THE DISPOSAL OF SPENT POWDEX[®] ION EXCHANGE MATERIALS

QUESTION B: Provide the design details and exact location of the storage building (referred to in contentions 6* and 11d). Include the structural design details to the extent necessary for the staff to determine the adequacy of the building to withstand hurricanes and floods. Also include the weight and dimensions of the steam generator lower assemblies to be stored in the building.

In the Matter of
Florida Power and Light Company
(Turkey Point Nuclear Generating Unit Nos. 3 and 4)
Docket Nos. 50-250 & 50-251 (Proposed Amendments to
Facility Operating Licenses to Permit Steam Generator Repair)

STEAM GENERATOR STORAGE
STRUCTURE

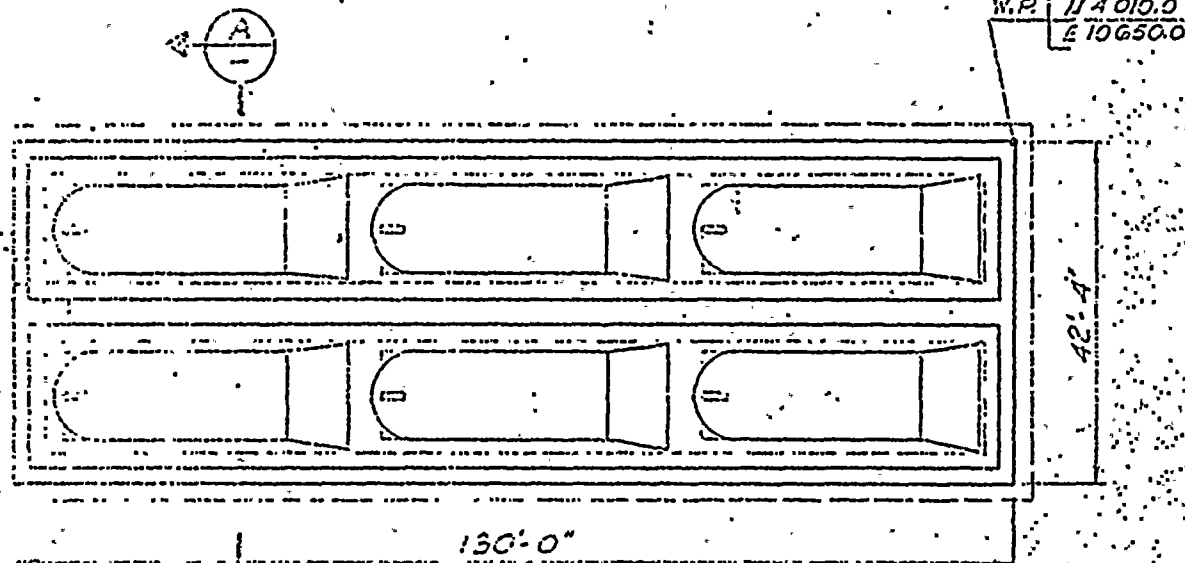
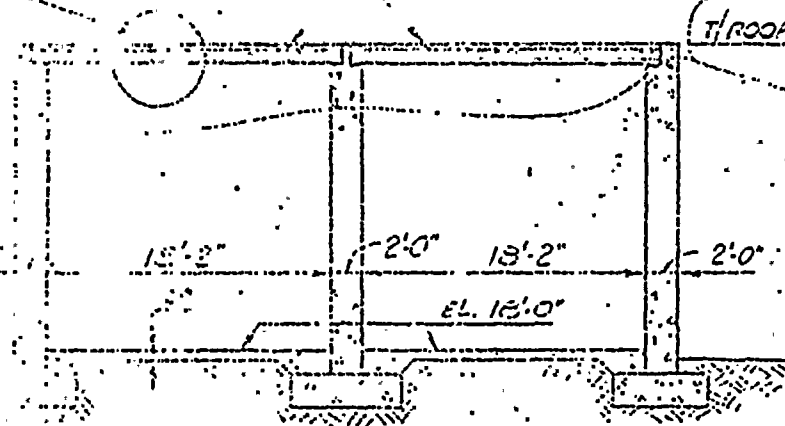
Provide the details of the method of sealing the steam generator lower assemblies; weld design, weld material, cap material and dimensions, corrosion protection, and any related information that will be needed to evaluate the possibility of radioactive material leaking out of the stored assemblies.

ANSWER: The conceptual design and nominal dimensions of the storage compound are shown on the attached figure. The final design might change depending on the outcome of ongoing engineering studies and evaluations. Each steam generator lower assembly with steel support saddles will rest on reinforced concrete

bearing pads. The compound will be designed and constructed in accordance with the South Florida Building Code, ACI 318, AWS D1.1 and AISC Manual of Steel Construction.

The approximate location of the storage compound in the laydown area is also shown on the attached figure. The current elevation of the laydown area ranges from +6 to +9 feet MLW. The approximate subsurface profile in the vicinity of the storage compound consists of 4 feet of limerock fill over 6 feet of muck underlain by Miami limestone. The existing fill and muck will be excavated to a minimum distance of 15 feet beyond the edge of the storage compound. The entire compound and lay down area will be backfilled or filled as required with compacted limerock fill to + 17' 6" MLW with perimeter slopes of 1-vertical on 3-horizontal. Heavy equipment transport, laydown storage, and heavy lift crane placements in support of repair and storage operations will require a minimum of 65 feet around the storage compound.

The limerock fill will be compacted to a minimum dry density of 110 pounds per cubic foot which based on laboratory tests yields allowable bearing capacity of approximately 15 kips per square foot, strength of cohesion of approximately 3 kips per square foot, and an internal angle of friction of approximately 39.

A steam generator lower assembly is approximately 39 feet long and 127 inches in diameter except for the last 6 feet 4 inches where the diameter expands linearly from 127 inches to 166 inches. The volume is approximately 3620 cubic feet and the dry weight is approximately 205 tons which yields a total vessel density of about 113 pounds per cubic foot.

The top of the assembly (approximately 13' 10" diameter) and the two channel head nozzles (approximately 31" diameter) will be provided with 3" steel shield plates. The two blowdown nozzles (approximately 2" diameter), one shell drain (1" diameter), and one instrument nozzle (3/4" diameter) will be provided with 1" steel shield plates. The shield plate materials will be ASTM A36 or equivalent and will be welded to the lower assembly openings. Only carbon steel weld materials will be used and the weld throat will be 1" minimum. Since the storage compound will have a water tight roof the lower assemblies will be protected from industrial corrodent and salt spray deposition, hence special corrosion protection will not be required.
